## ASSESSMENT REPORT

### SITE 8C, SYDNEY OLYMPIC PARK SSD 6059 MOD 1

**Figure 4:** Proposed Level 1 floor penetration and void

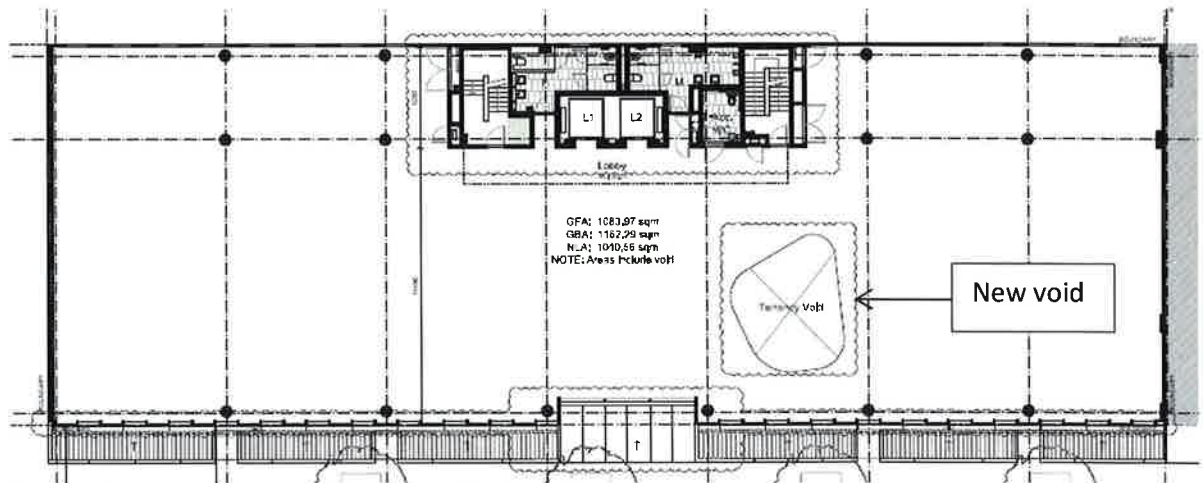
<p><i>Rooftop Modifications</i></p>	<ul style="list-style-type: none"> <li>• an extension to the lift shaft to provide access to an outdoor area for future occupants;</li> <li>• installation of decking, landscaping and pergola; and</li> <li>• re-arrangement of plant, and installation of a new back-up generator and aluminium screen.</li> </ul>
